SIGNAL ENGINEERING INSTRUCTION
10 July 2006
ESI 06 04A

Westinghouse LED signal modules

Figure 1: Example of Label

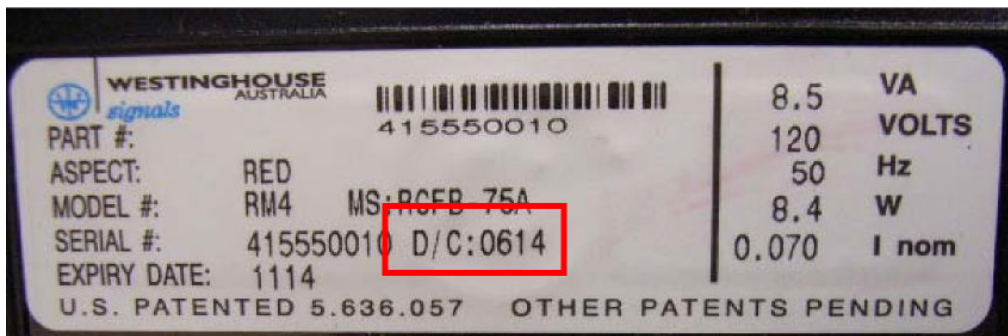
All RM4 (200 mm) LED Signal modules with a manufacturing date between 10th February 2006 and 27th April 2006. The manufacture date can be read from the label on the rear of the signal following the identifier "D/C:" This is the manufacturing date code in the form YYWW (year and week number). Affected signals could have date codes between 0606 and 0617. Some signals at the extreme of this range may be OK.

Signal maintenance staff are to inspect all Westinghouse LED signals in stock or installed during 2006. For the items identified as below, make a record of the items, location and type. This is to be reported to the Signal Manager for the region. The Signals Manager is to make arrangements for the change out of the units. The Signals Manager is to liaise with the Westinghouse representative for the replacement of the units. The Signals Manager is to maintain a list of the defective units and details of their respective change out.
